**Re: Hoffmantown West Church, 6440 Coors Blvd. NW**  
**Approval of Permanent Certificate of Occupancy (C.O.)**  
**Engineer's Stamp dated 08/24/06 (D-17/D93)**  
**Certification dated 05/22/07**

**Re: Hoffmantown West Church  
Grading and Drainage Plan  
Engineer's Stamp dated 8-29-06 (D12-D1)**

Re: Drainage Report for Hoffmantown West Church, ZAP D-12  
Engineer's Stamp Dated March 28, 2005

**Re: Hoffmantown West Church Drainage Report**  
**Engineer Stamp date 12-28-05 (D12/D1)**

## SITE GRADING AND DRAINAGE PLAN

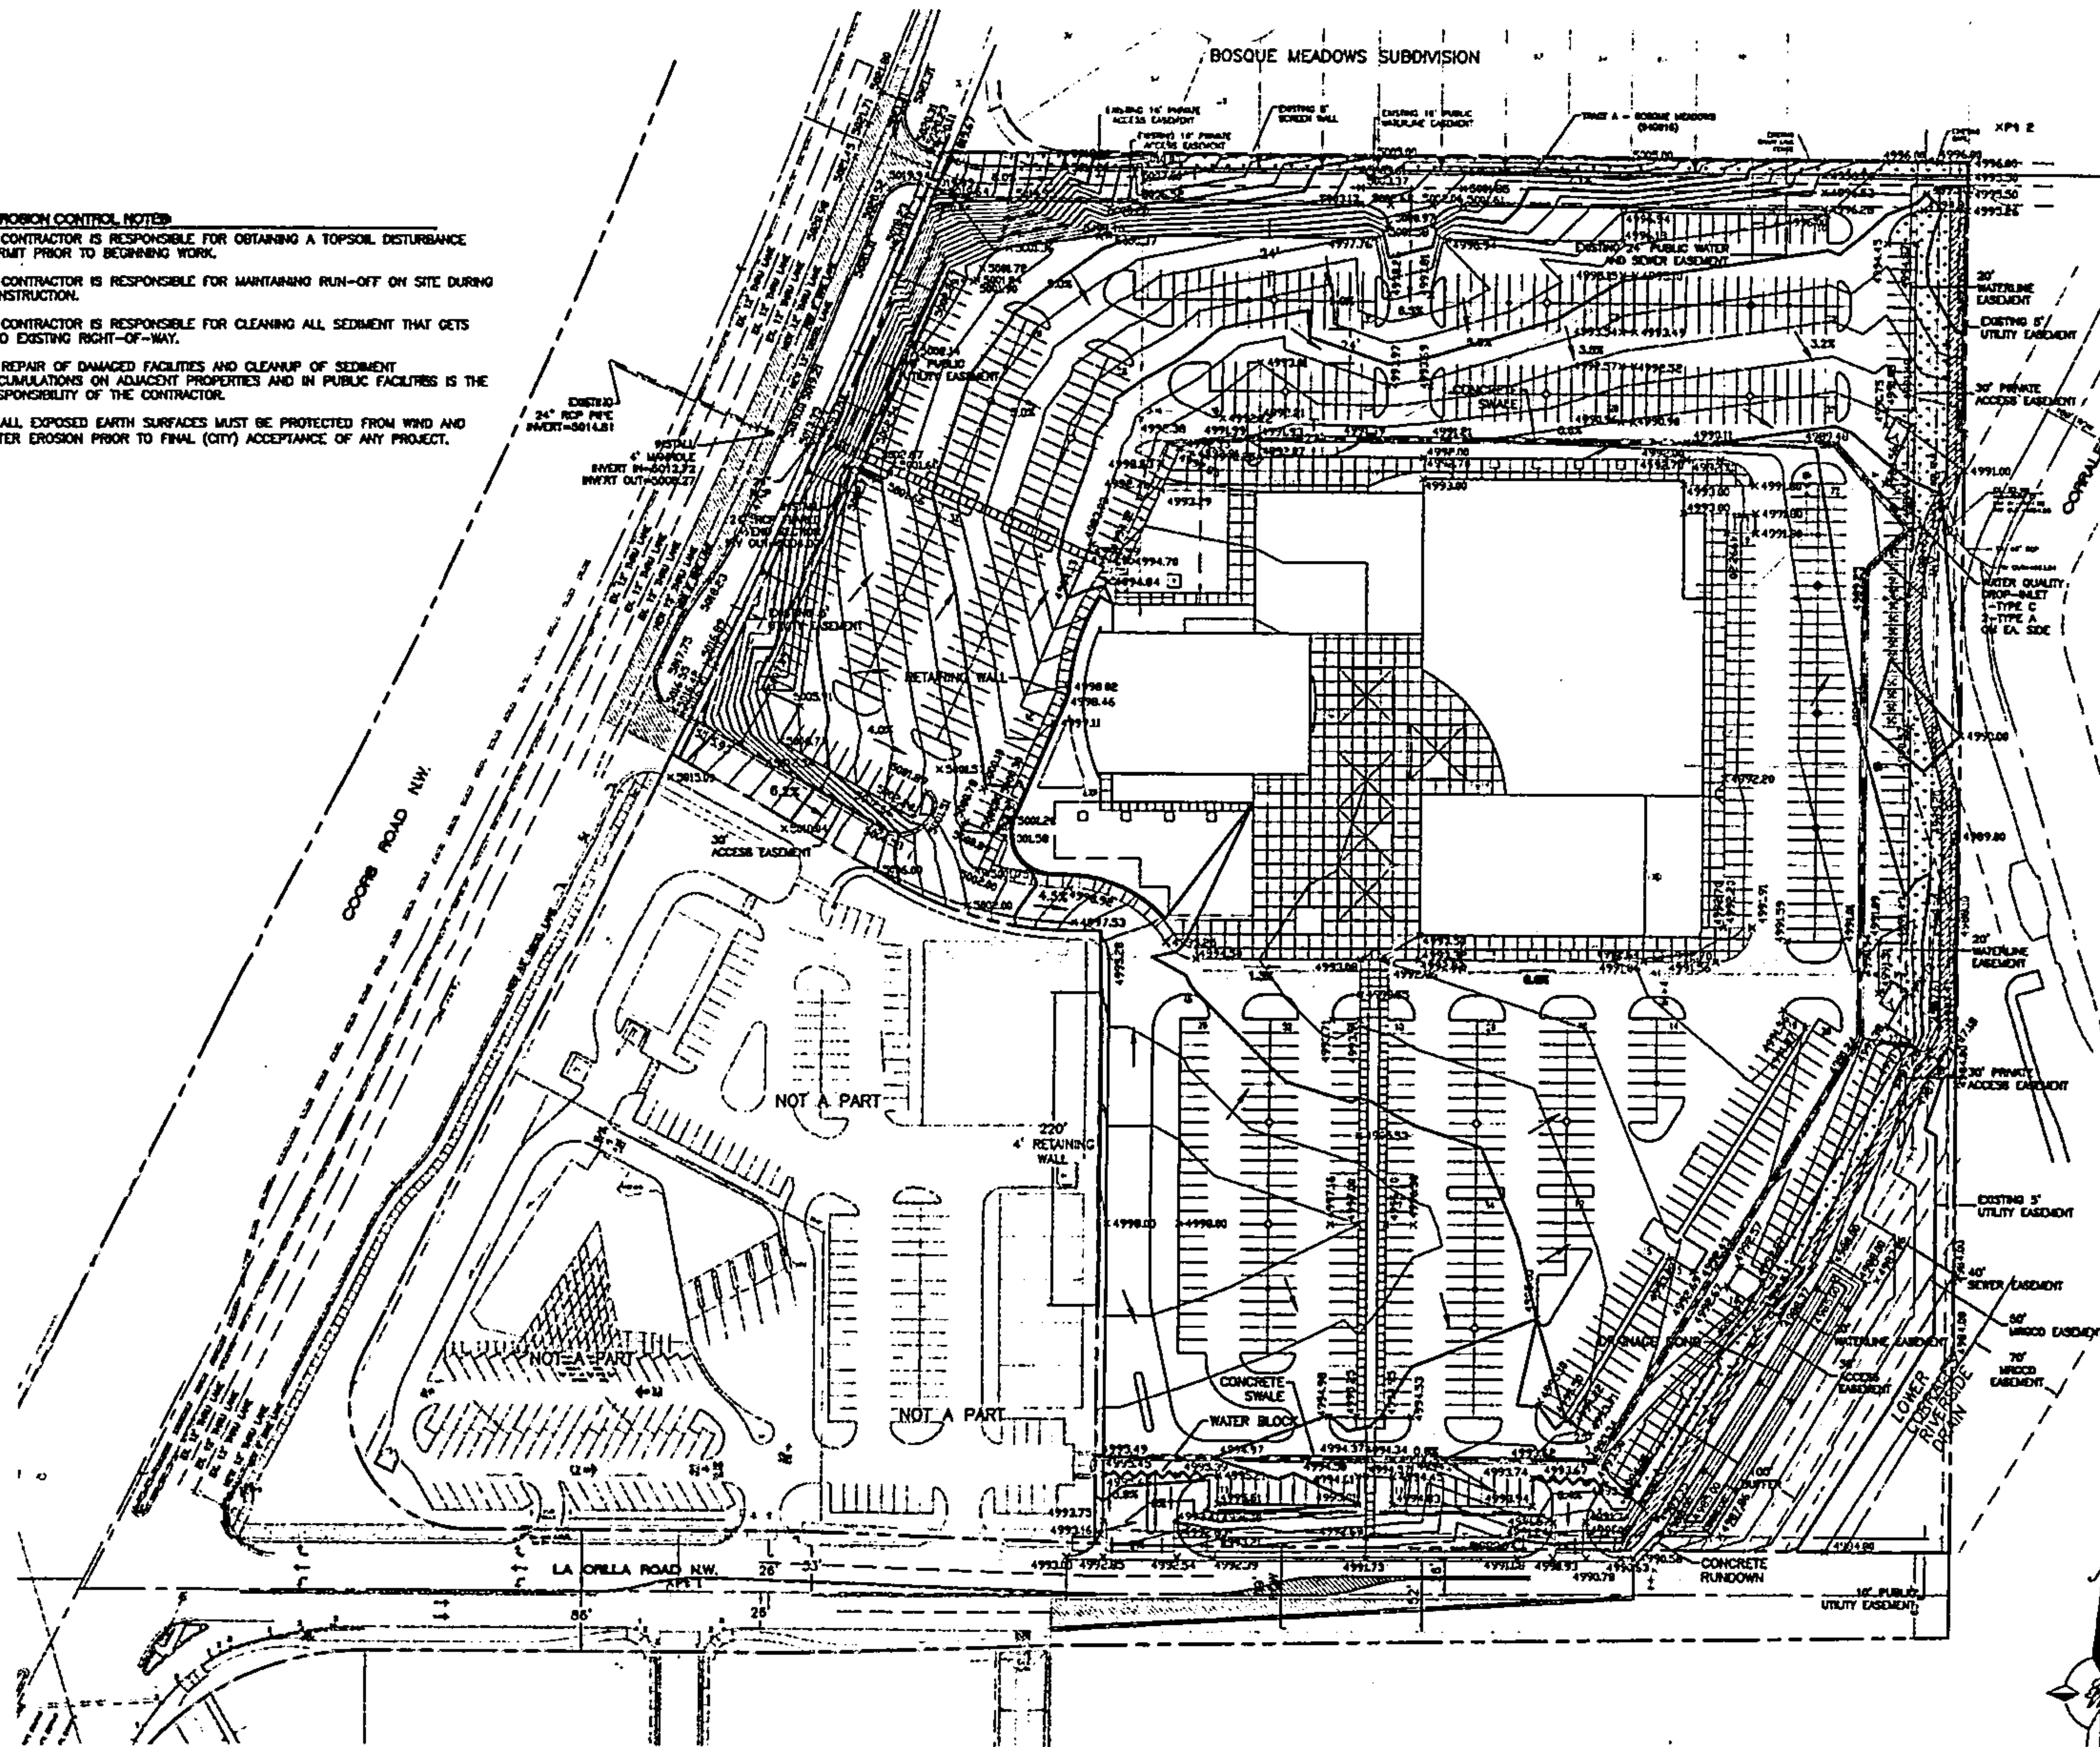
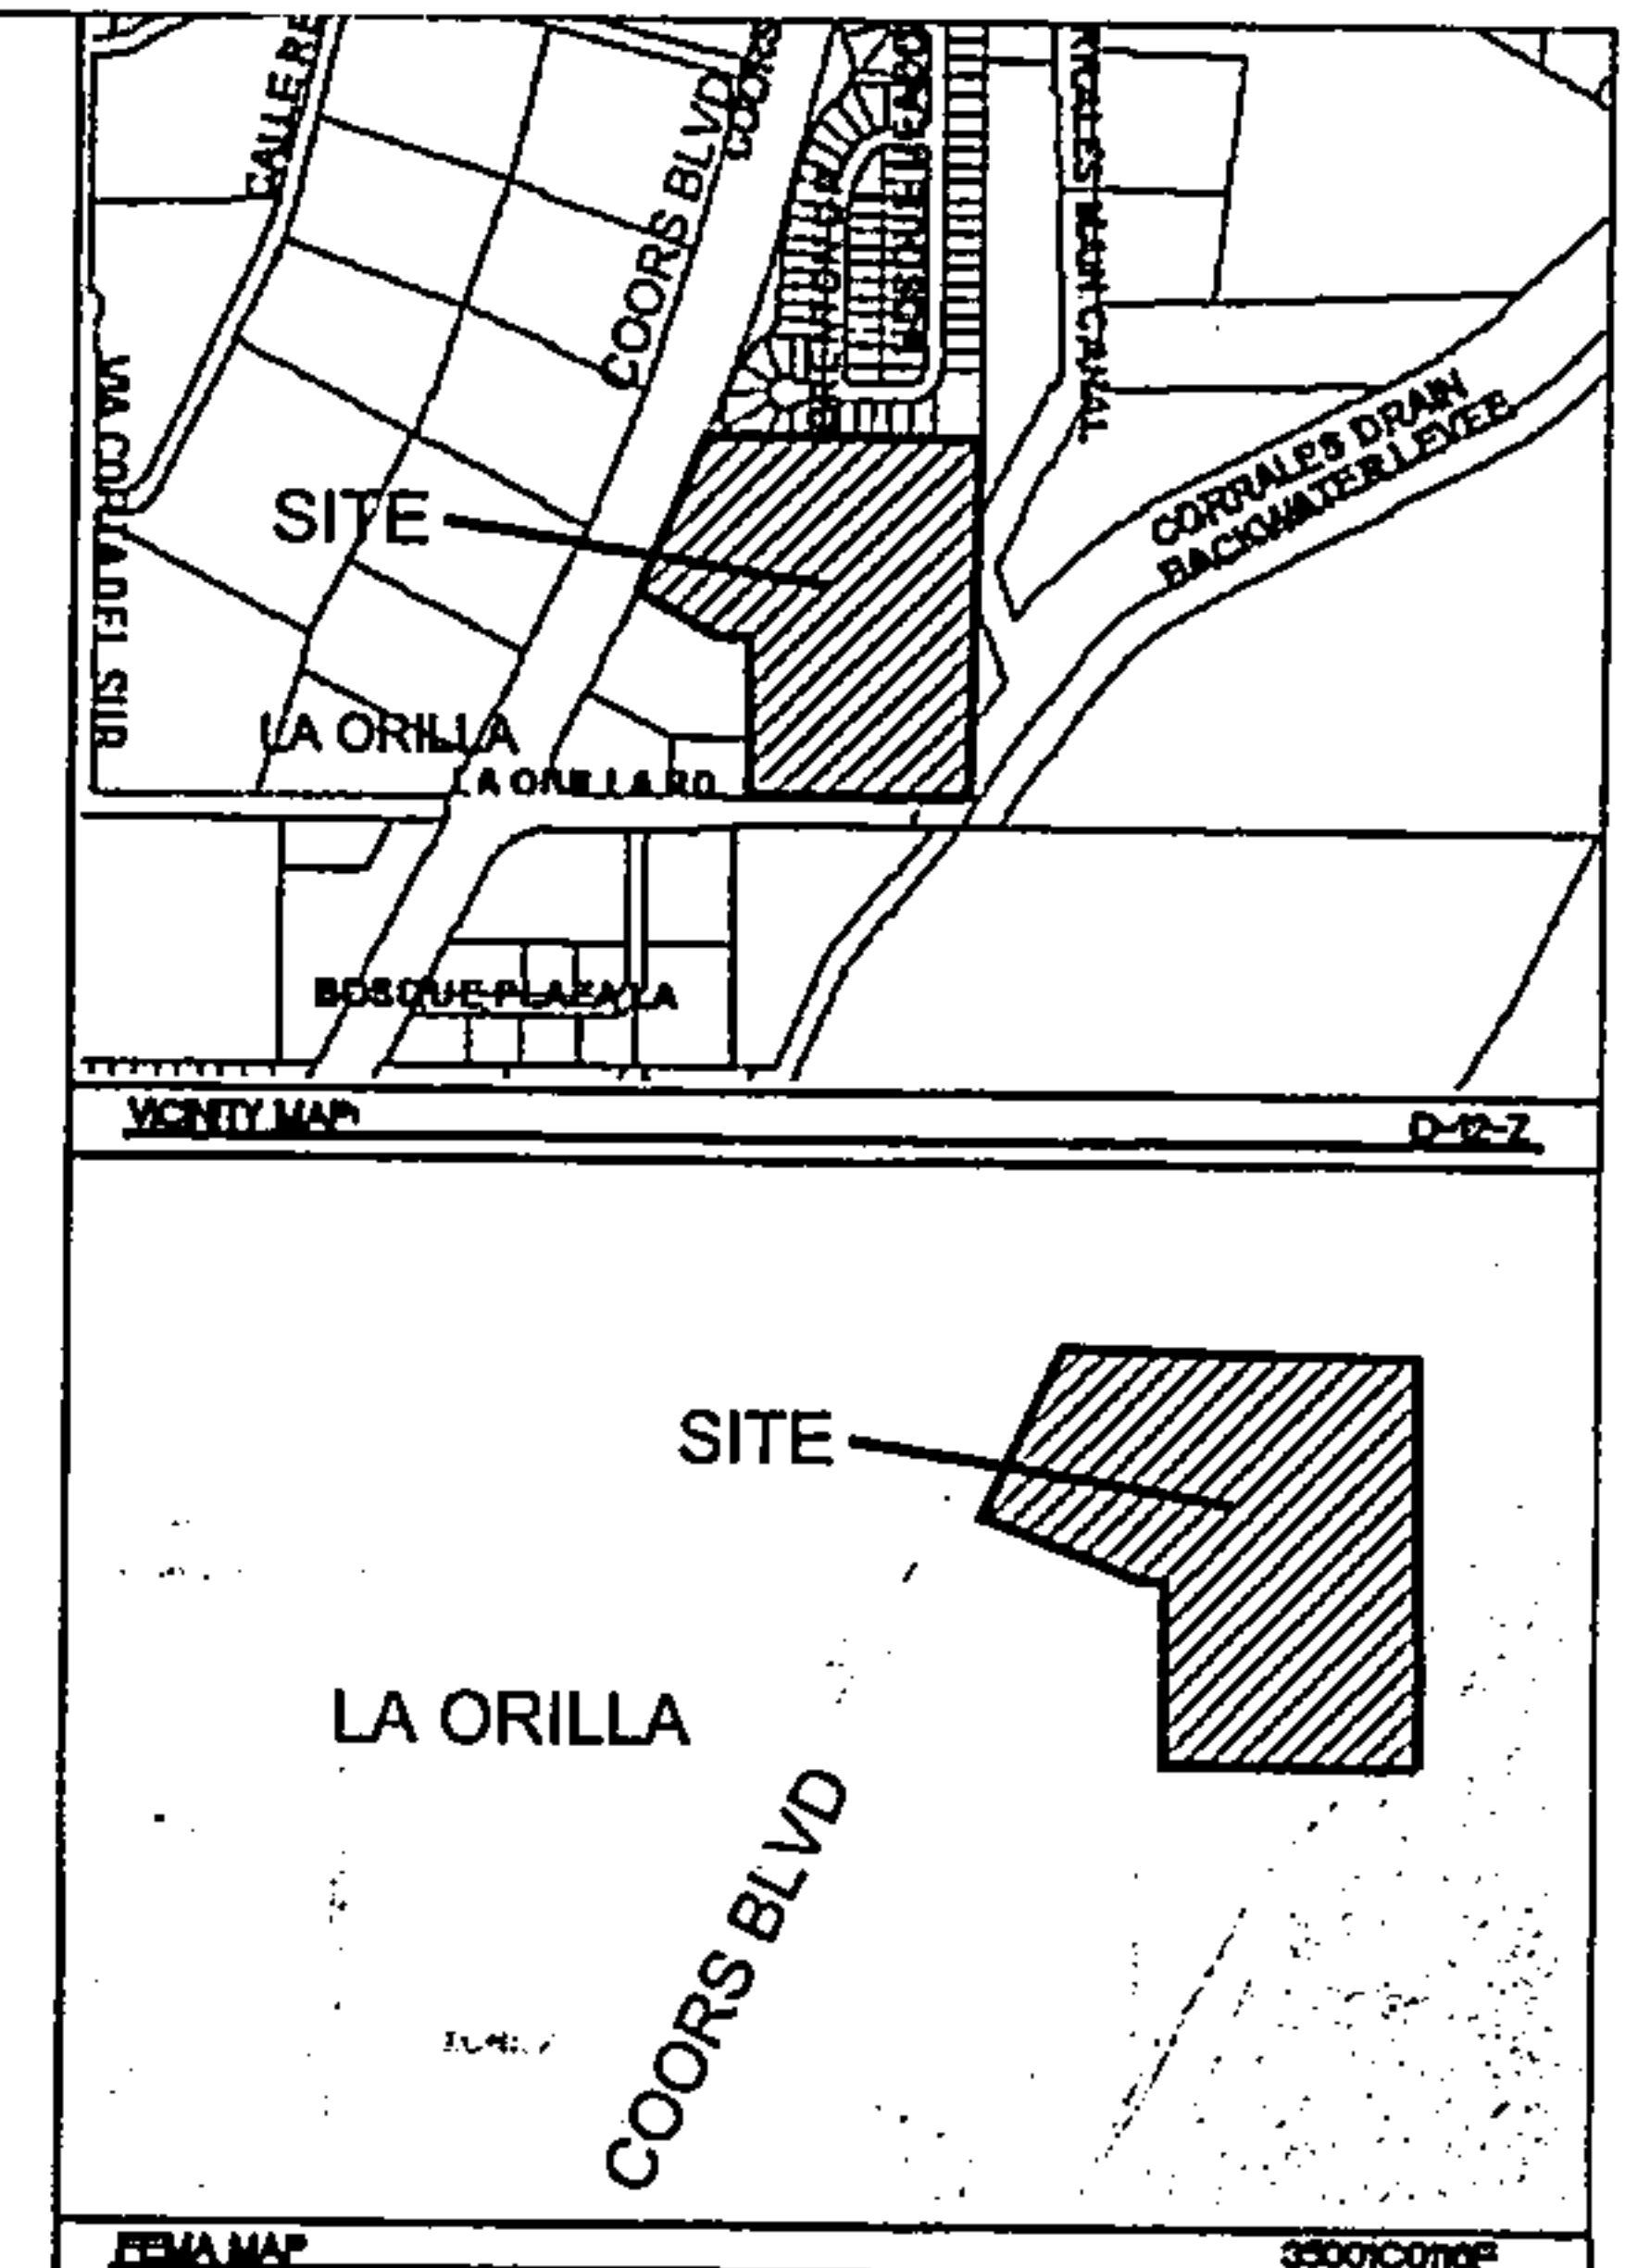
AMAFCA does not approve the Grading & Drainage Plan. There are some key drainage discharge conditions that have not been adequately addressed in the Drainage Report. The primary discrepancy is how you arrived at the allowable discharge rate. This site is included in AMAFCA's "North Coors Drainage Management Plan, Middle Area" (NCDMP, February 1997), which was prepared to update hydrology, development, and discharge conditions in the area. The allowable discharge from Bosque Meadows Subdivision, including the offsite basin that drains through it, is 35 cfs per the NDDMP. Since, according to your report, it discharges 32 cfs, that leaves 4 cfs allowable discharge not going into the canal. The allowable discharge from the Hoffmantown site, including the offsite basin west of Coors Boulevard, is 98 cfs. Please revise the Drainage Report to reference the NCDMP and the allowable discharge.

Another key discharge condition that must be addressed in the report is the desedimentation requirement in the NCDMP. After discussion with MRGCD, AMAFCA and MRGCD are going to require surface water quality treatment for sediment, pollutants and trash and, to be determined on a case by case basis, possibly additional in-line storm water treatment facilities, such as a Stormceptor manhole. There is a pond shown on the southeast corner of the site, but it does not appear to receive any storm water runoff.

The Drainage Report should also address the size and capacity of the existing storm drain outfall to the canal. If you have any questions, please call me at 884-2215.
